EAST GOSHEN TOWNSHIP PLANNING COMMISSION

Meeting Agenda

Wednesday, August 12, 2020

RE: 1303 Goshen Parkway – Preliminary / Final Land Development Jabil Finishing Plant Expansion – Fire Service Site Plan 1303 Goshen Parkway, West Chester, PA 19380 Mainstay Project Number: 19360

C0.11

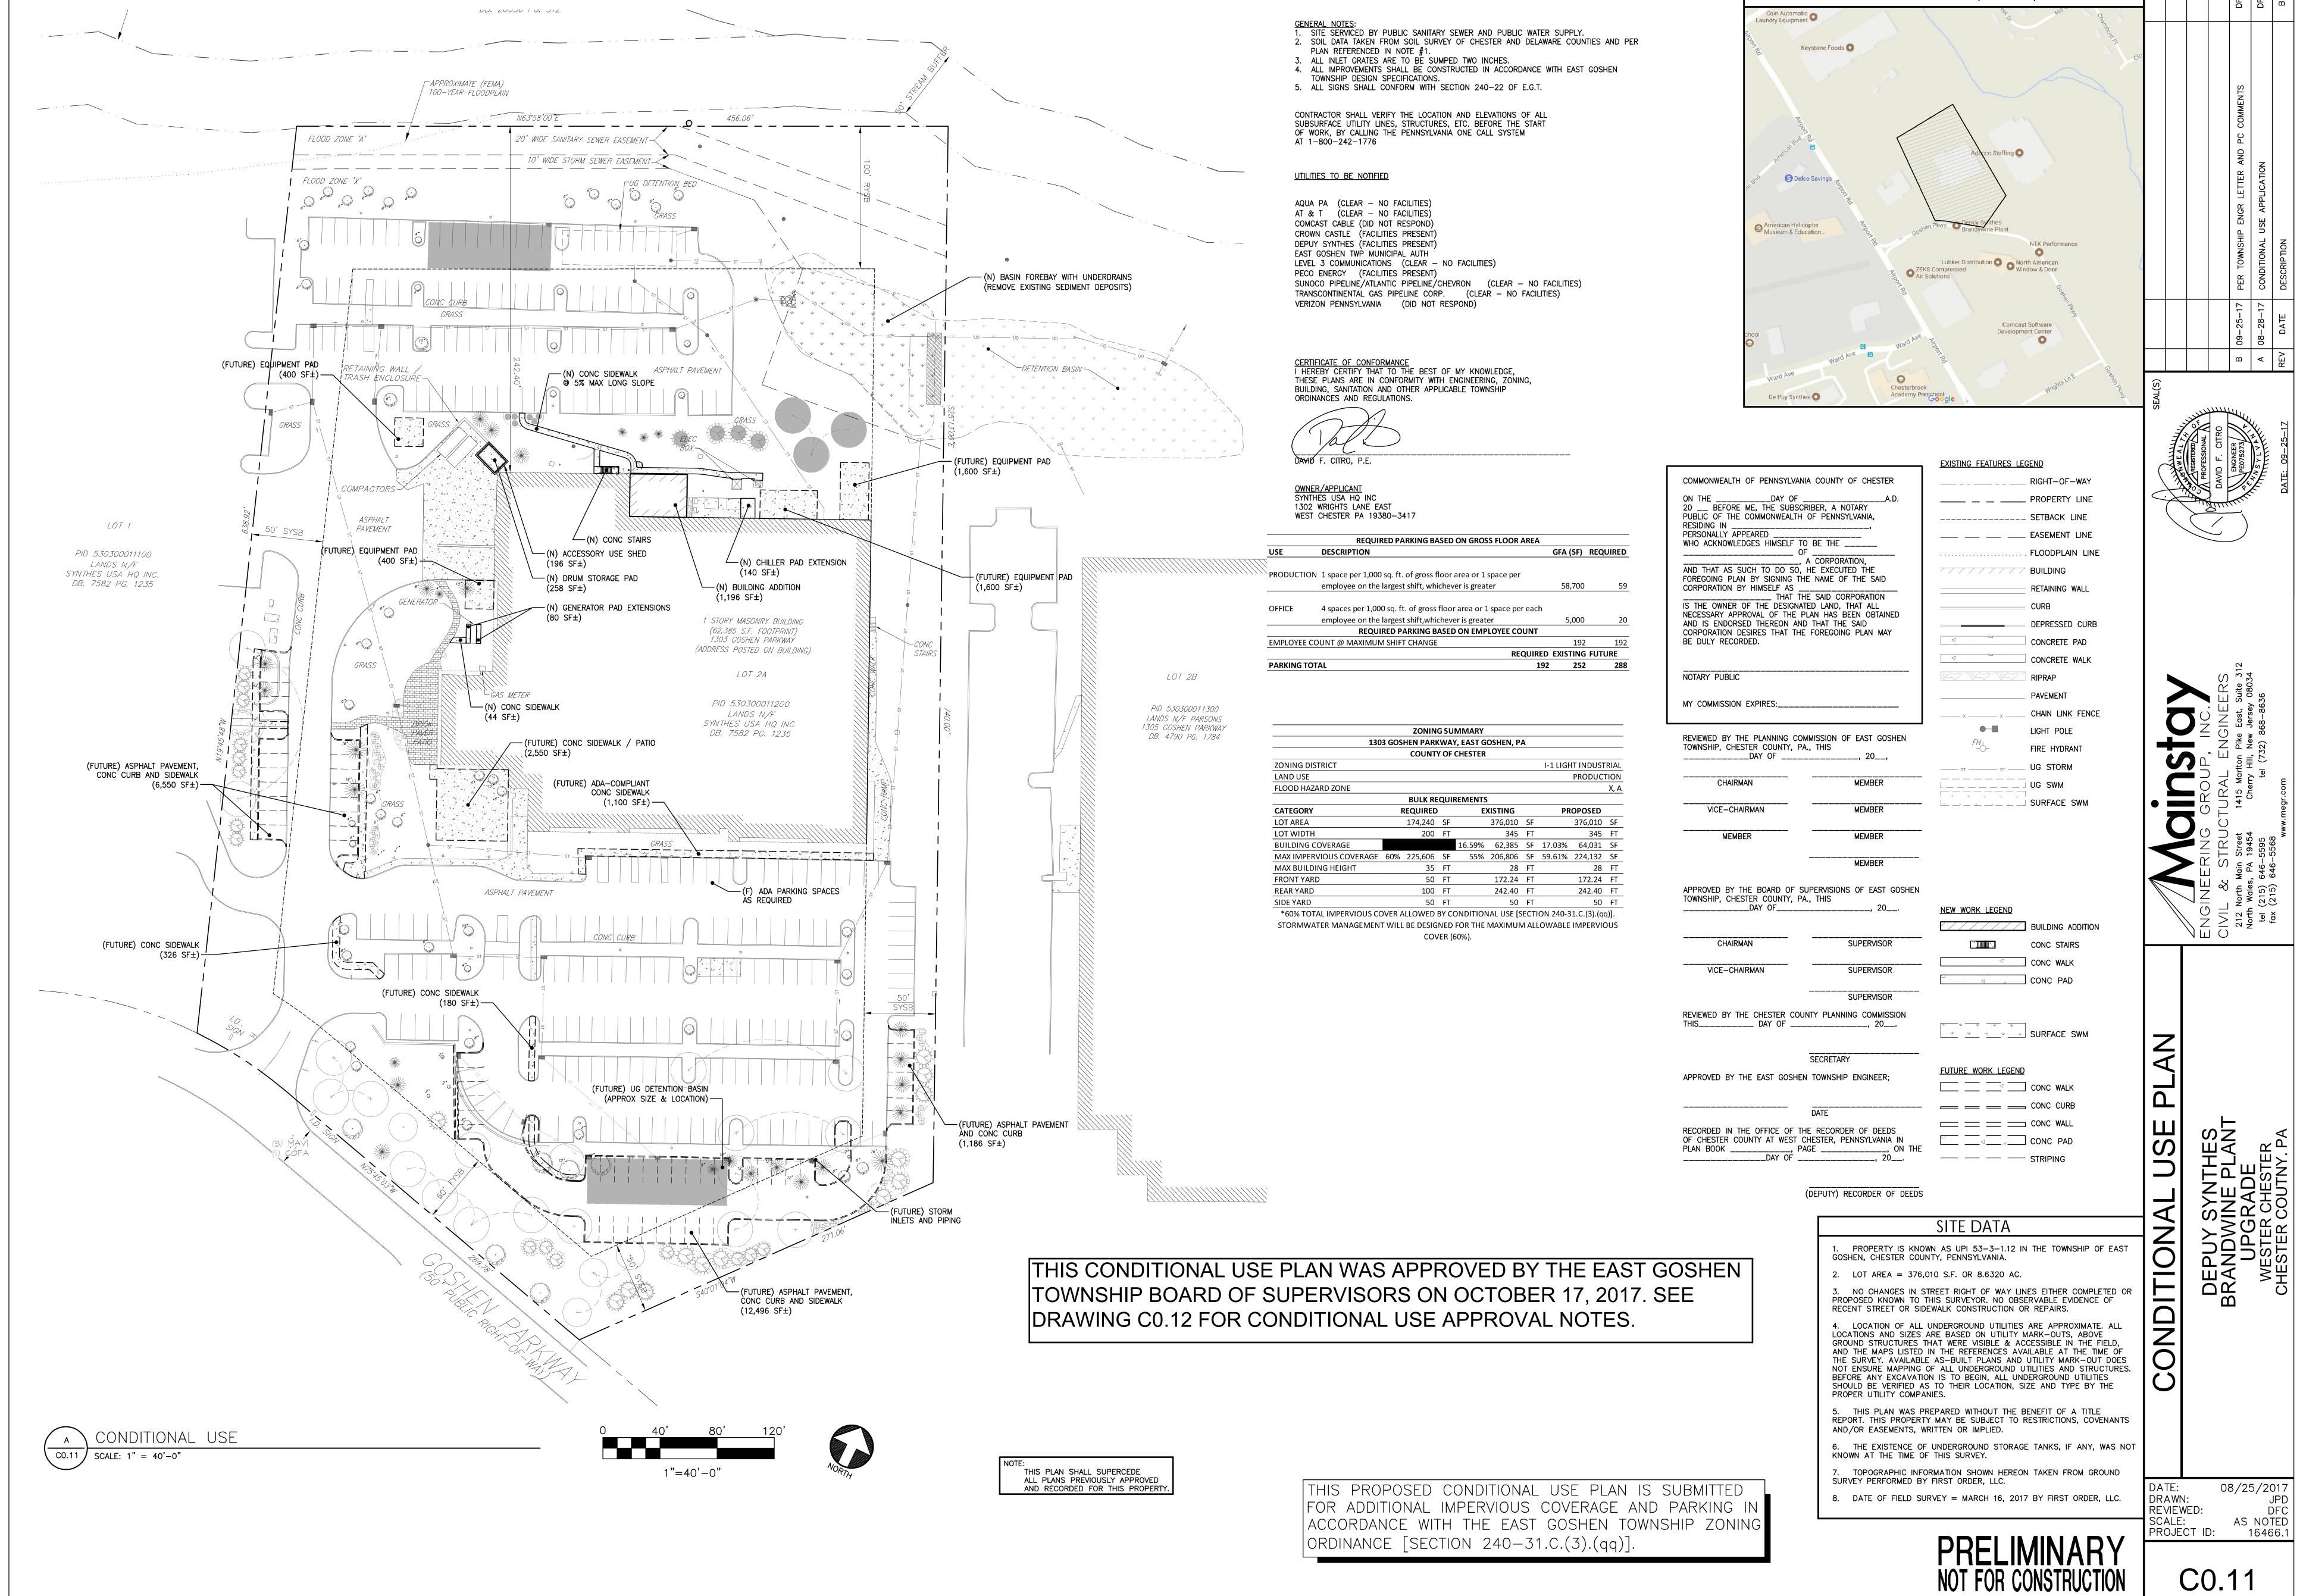
27. We recommend the Conditional Use approval be noted on the plans and referenced below the Zoning Summary table (Sheet C0.12) regarding the impervious coverage.

Resolved. The Conditional Use approval has been added to the plans below the Zoning Summary table.

SITE UTILITIES PLAN (1 OF 2)

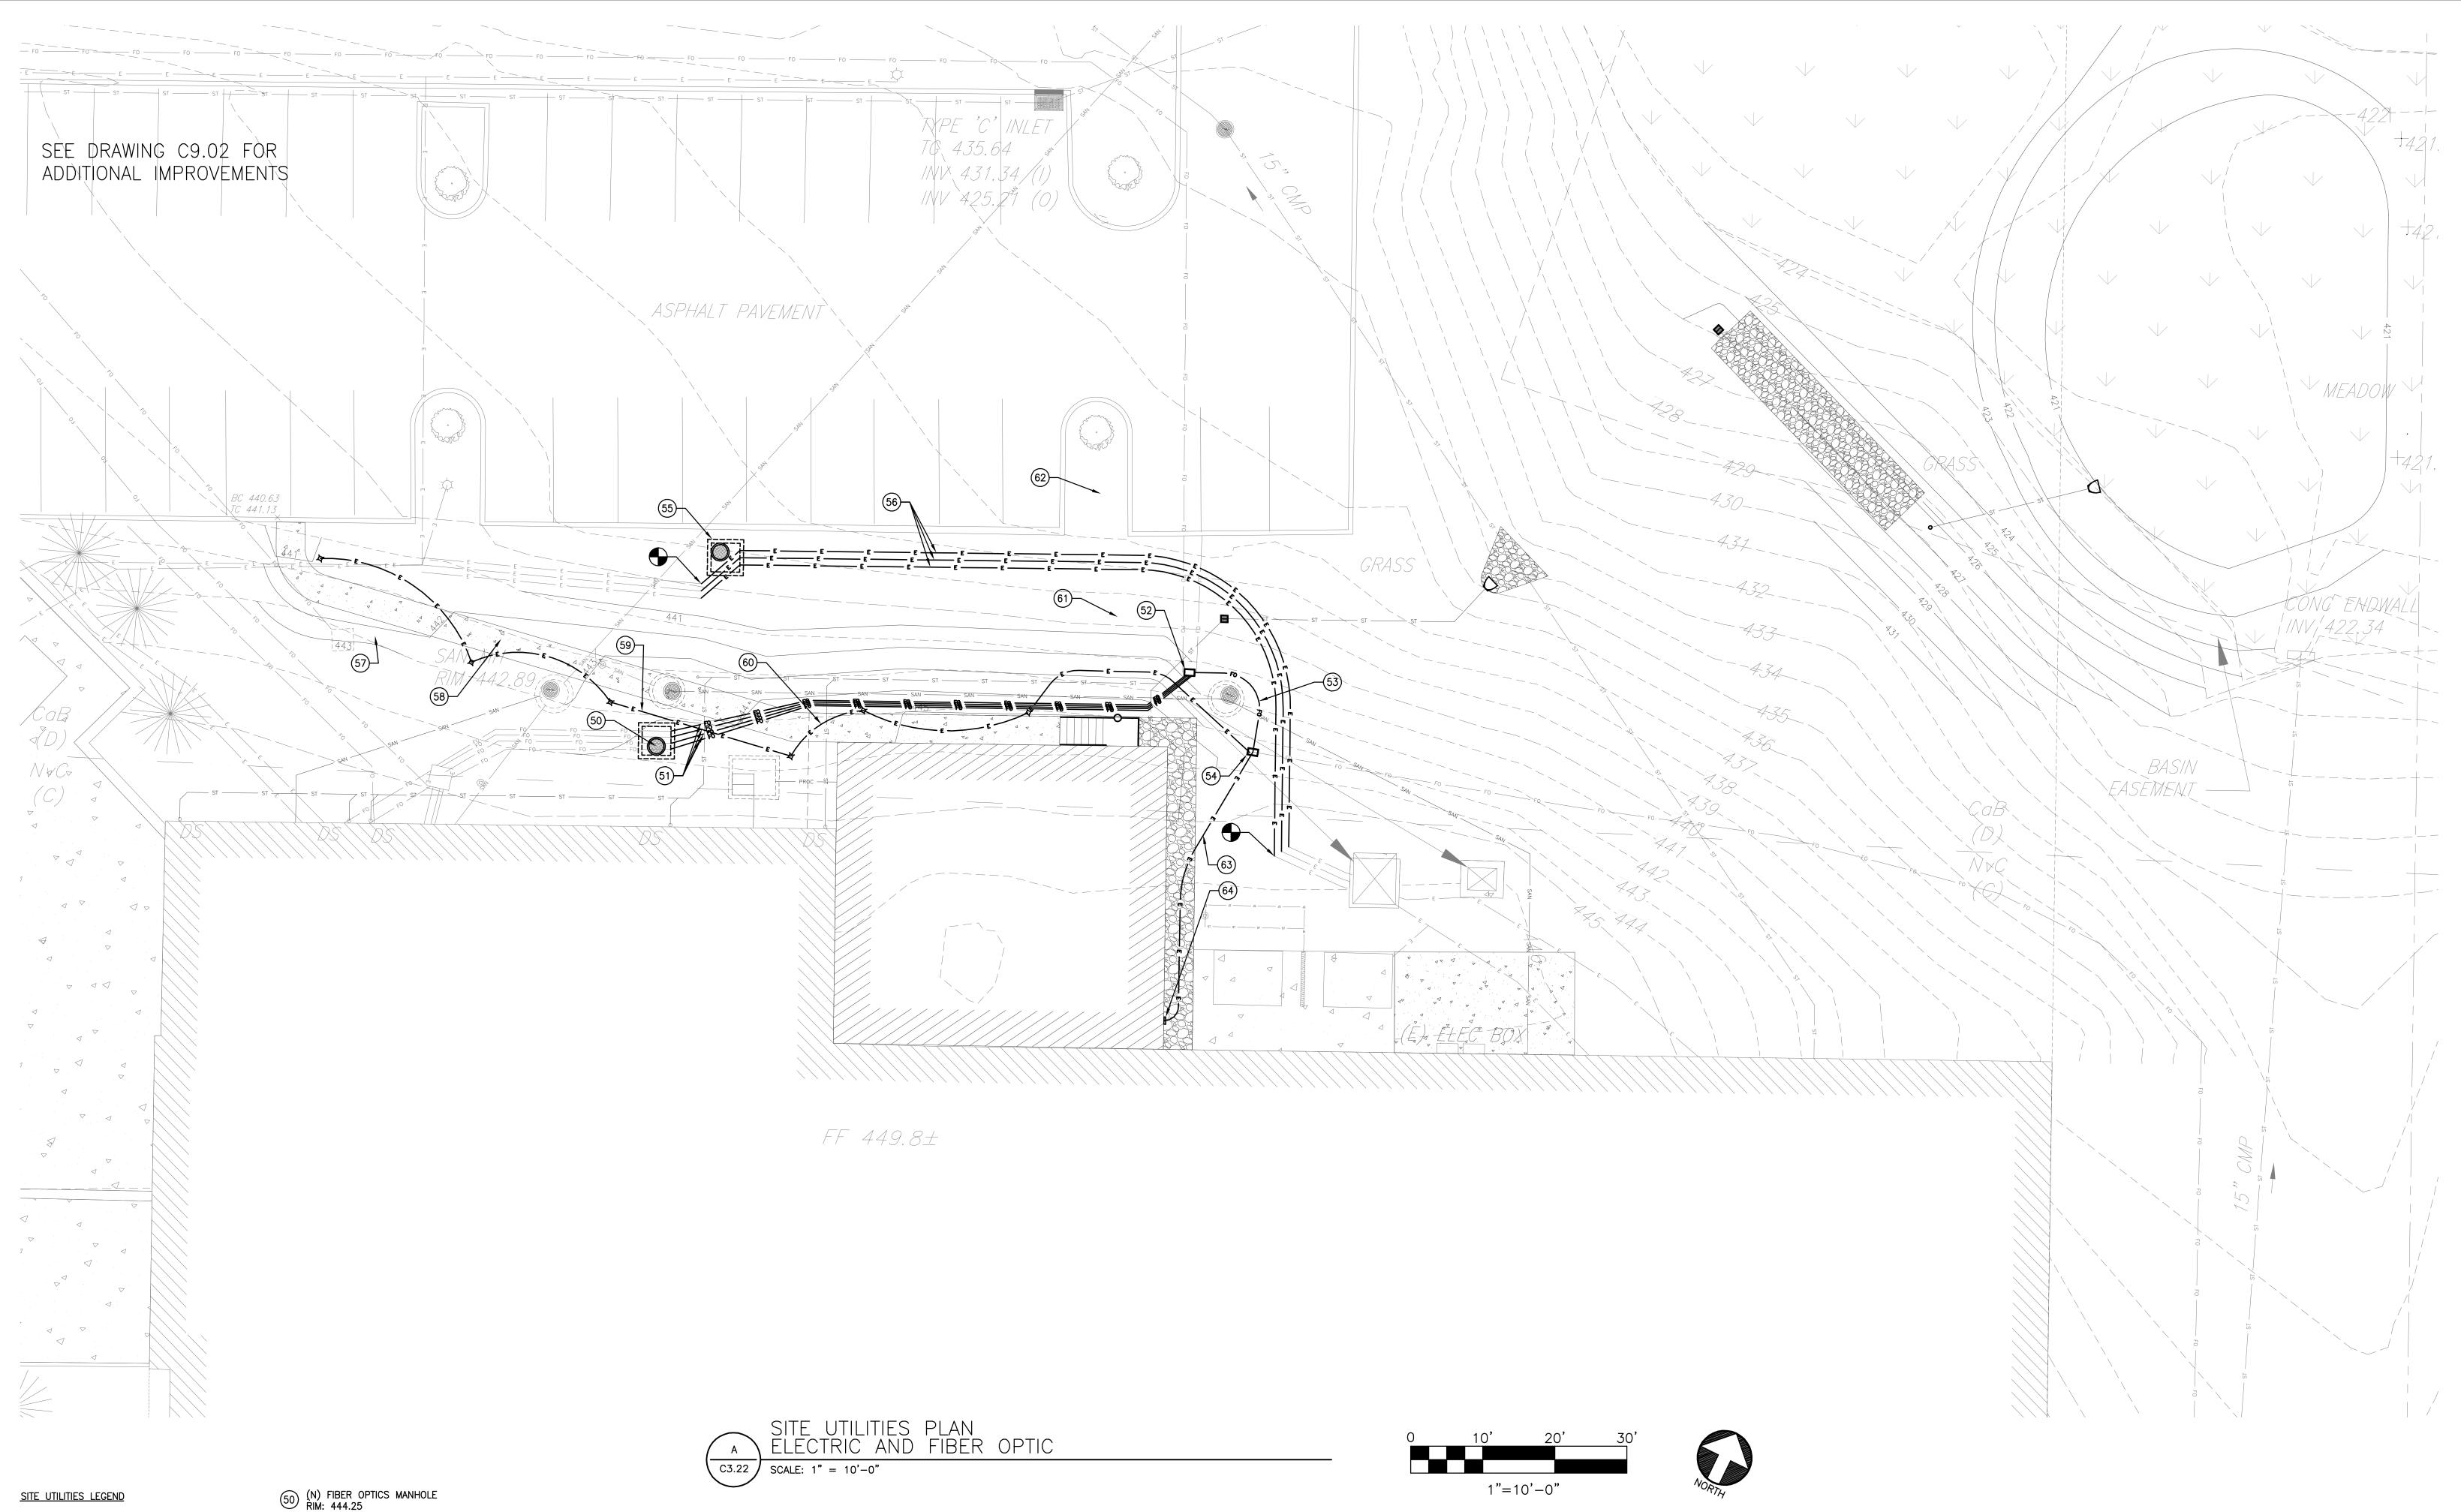
4. A detail for the proposed lighting shall be provided to confirm the light is completely shielded and/or covered by an appropriate translucent cover. (§240-27.C(7)(b))

Outstanding. It appears the applicant has provided a detail for the lighting adjacent to the walkway however no detail has been provided for the parking lot light.

MEG RESPONSE: After evaluation, the parking lot light has been removed from scope, and no detail is required.
